Our File: HCC22/126
Enquiries: David Hajzler
Telephone: 9205 2489

RE: SMALL LOT HOUSING CODE STAGE 2 STANDARDS REVIEW – HUME CITY COUNCIL SUBMISSION

Attachment 1: Case Study: Craigieburn R2 PSP medium density typologies and SLHC developments

PSP Future Urban Structure

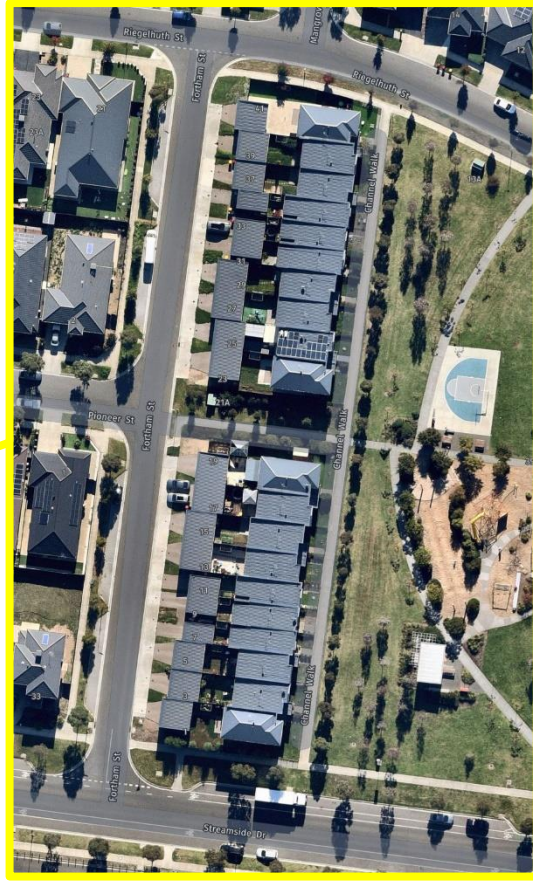
Medium density housing in hatched lines around schools, open space, activity centres

Medium density developments in red (excluding detached or semi-detached dwellings)

1-41 Fortnam Street, Craigieburn

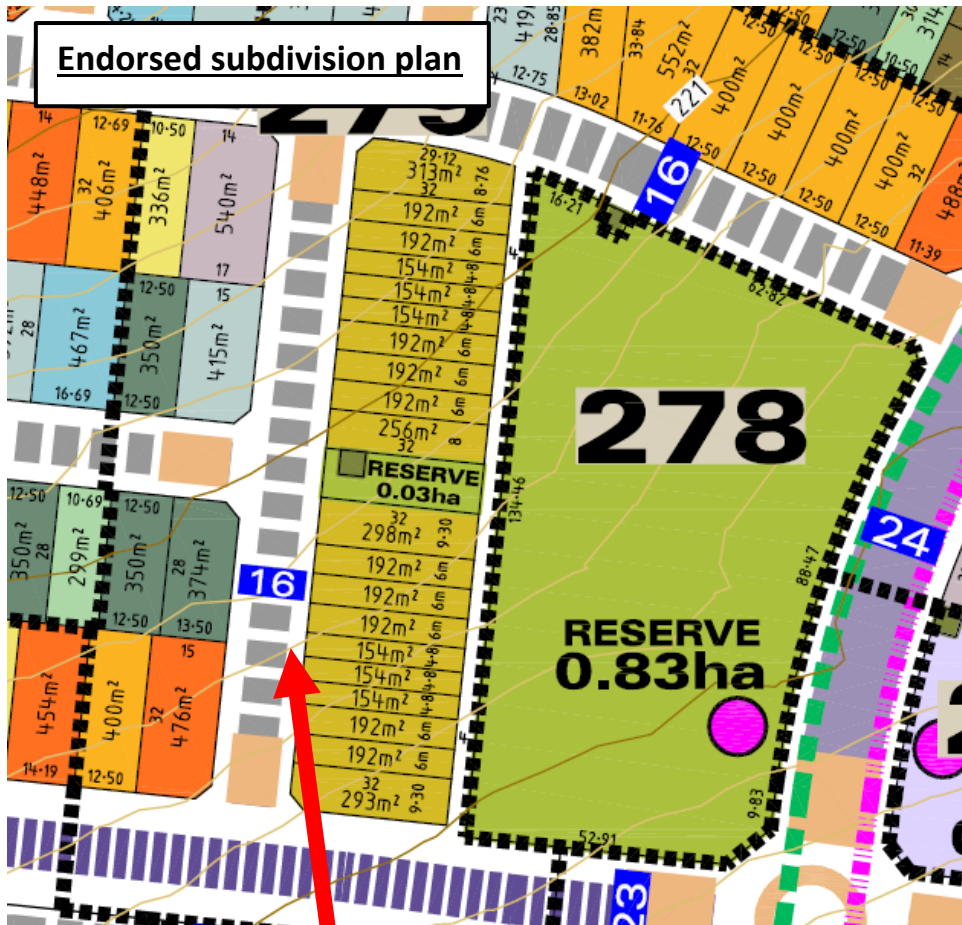
Poor public realm and amenity on rear street characterised by:

- Large amounts of concrete and hard surfaces for driveways
 - Little opportunity for street tree planting or landscaping
 - Exacerbates urban heat island
 - Increased stormwater runoff
- Cars parked on nature strip
- Dead frontages due to wall of rear garages
 - Lack of passive surveillance
 - Pedestrian safety concerns

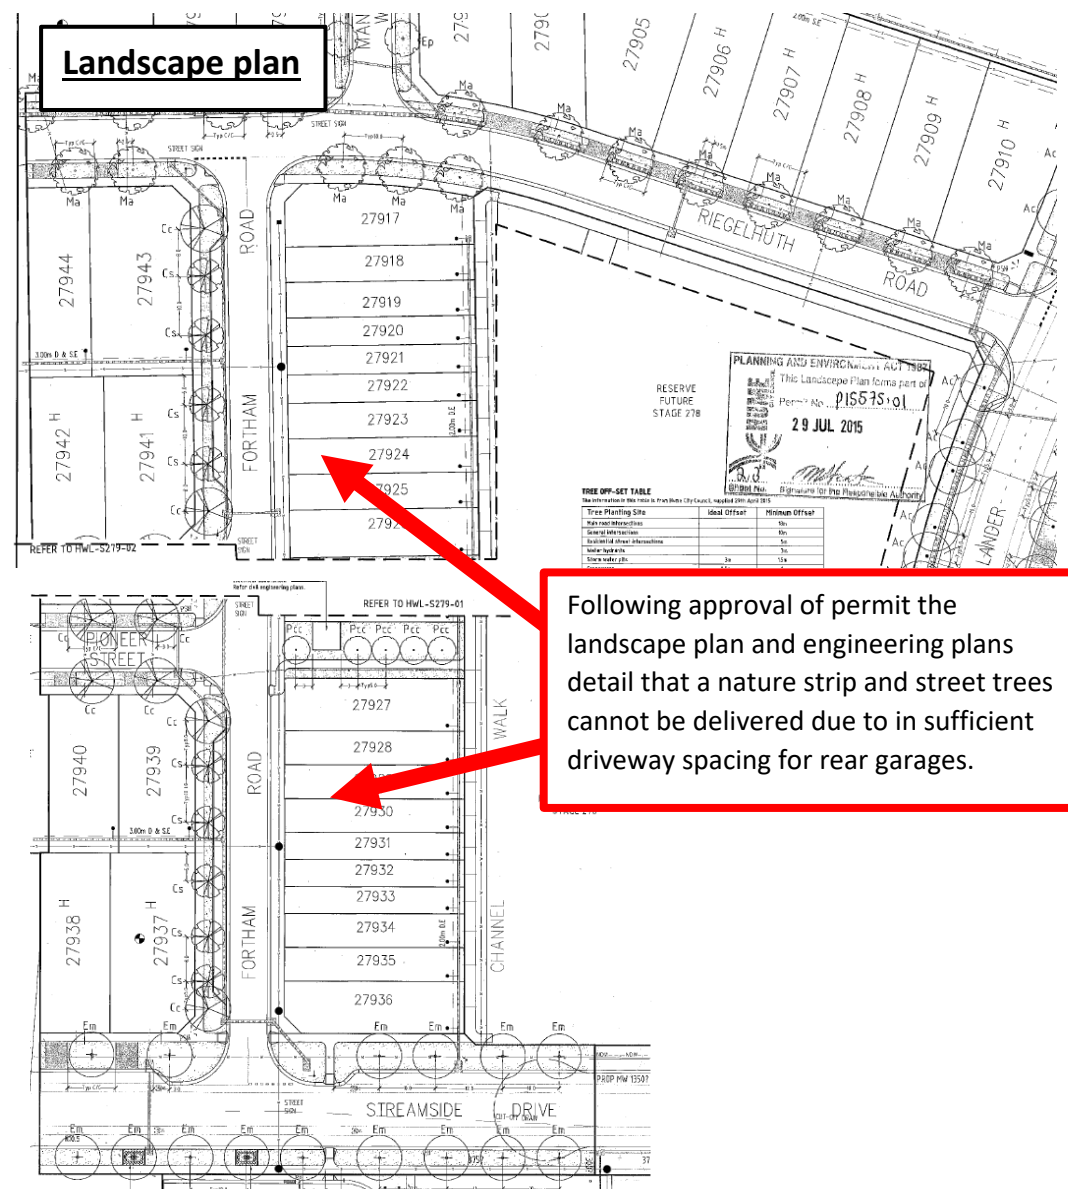
Lack of detail in planning permit subdivision plans. 16m access level 1 street proposed that would normally accommodate car parking and two 2.85m wide nature strips suitable for medium to large canopy trees.

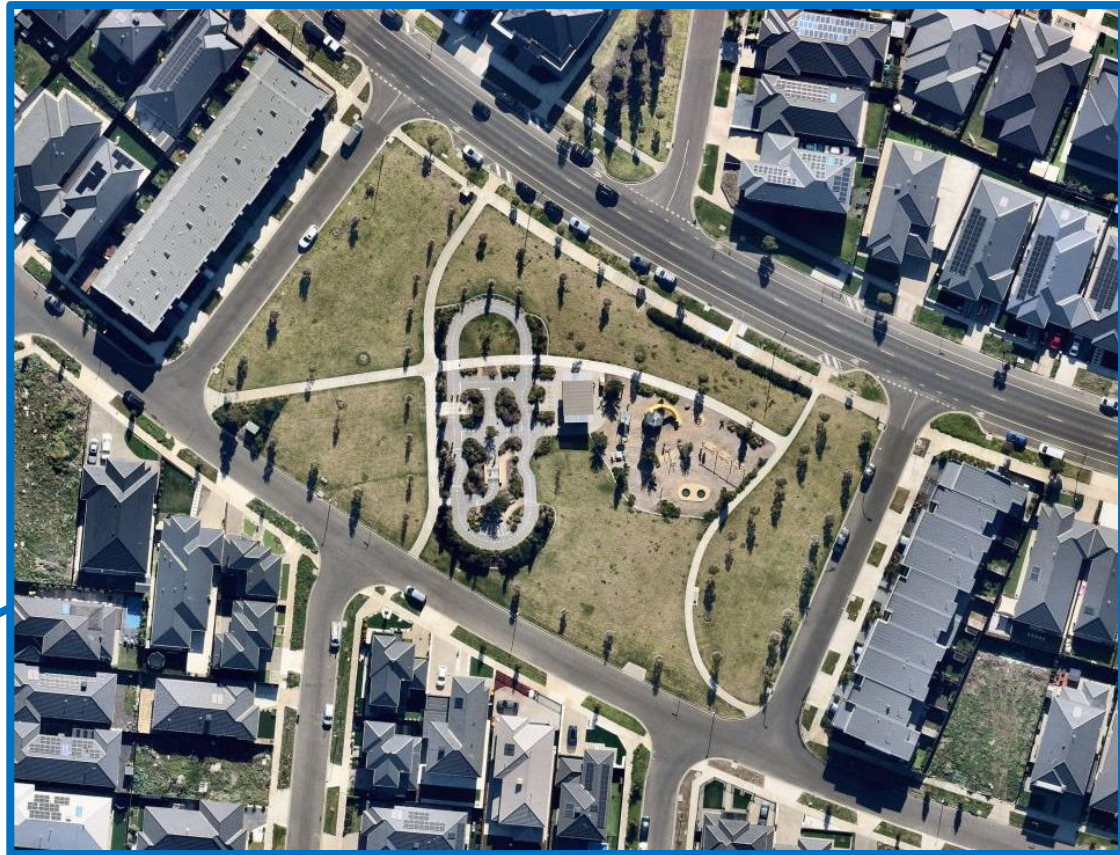
16m Access Street Level 1 required for access and waste services to properties to the west, demonstrating the need for neighbourhood scale assessments of the impacts of SLHC.

1-19 Century Way and 2-20 Abbington Street, Craigieburn

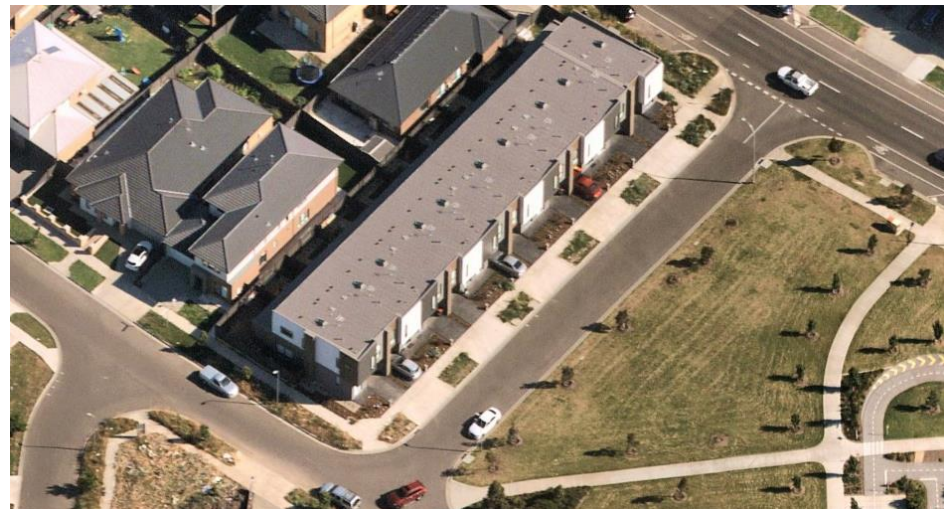
Poor public realm and amenity on front street characterised by:

- Large amounts of concrete and hard surfaces for driveways
 - Little opportunity for street tree planting or landscaping
 - Exacerbates urban heat island
 - Increased stormwater runoff
- poor frontages due to walls of garage doors and front doors
